From:
Sent: 28 June 2024 17:39
To: Nick Hirst
Cc: DCAdmin
Subject: Planning Application 2024-91236 - Poor Design
Attachments: landing_window_contradiction.pdf

The plans, for plots 34 and 35, show a window, at the top of the landing, on the second floor.

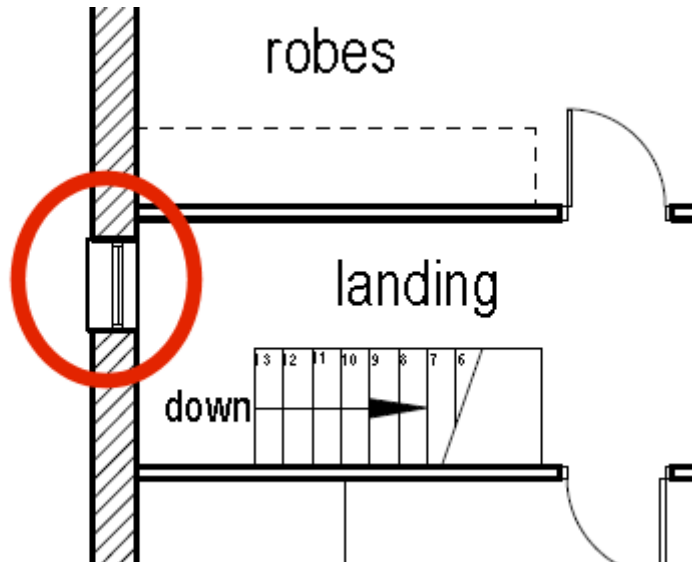
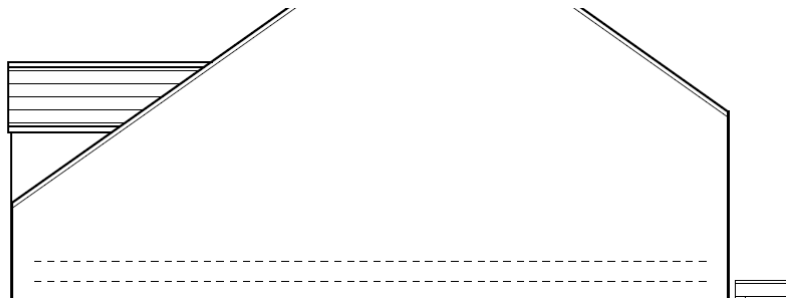
The image, right, shows the window highlighted.

The image below, which shows the same side elevation, shows no such window.

This is yet another example of poor design, where plans contradict.

In this case, the contradiction is seen on the same page.

Is the window being applied for, or not?

And, if it is, what are the proposed dimensions?

Is the glass obscured?

Would the window open, or not?

Answers, to these questions matter because side windows, such as the window depicted, have mandatory requirements to comply with.
